Site Instruction

Project Name: AQUAVISTA - Bayside
Client: TRIDEL Corporation
To: TRIDEL Corporation
Attention: Chadi Loza
Fax number: -

Project No.: 8489D
SI No.: E 021
Page No.: 1 of 1+ 1 attached
Office: Toronto
From: Sunanda Perera
Tao Li

Title: Revision – Artscape Security System Riser

1 SECURITY RISER DIAGRAM
N.T.S.

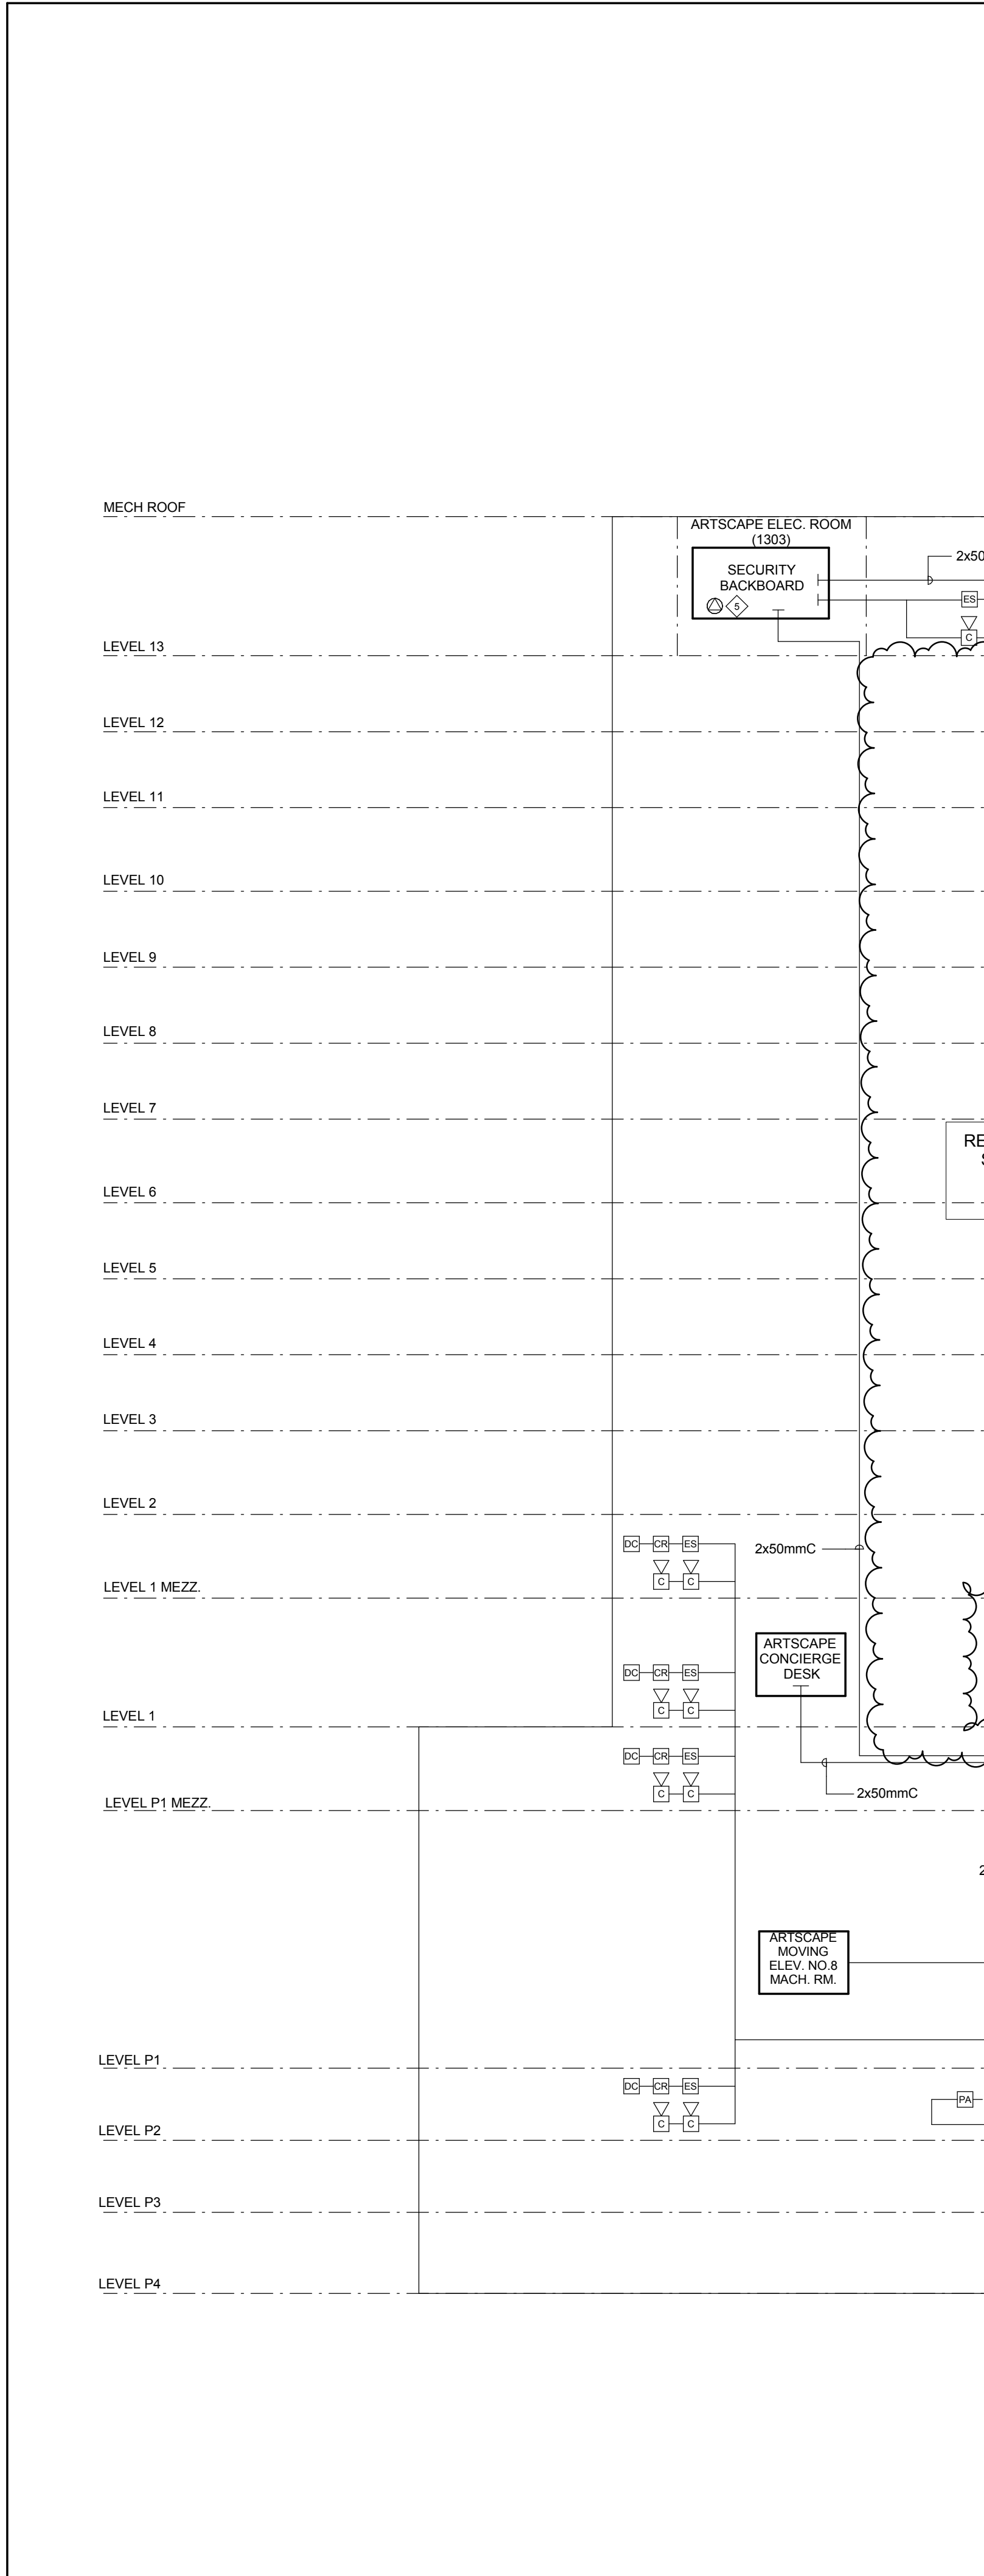
Drawing No.	Drawing Issued	Items
E4-06	Yes	Delete typical suite riser conduits to Artscape security system as shown.
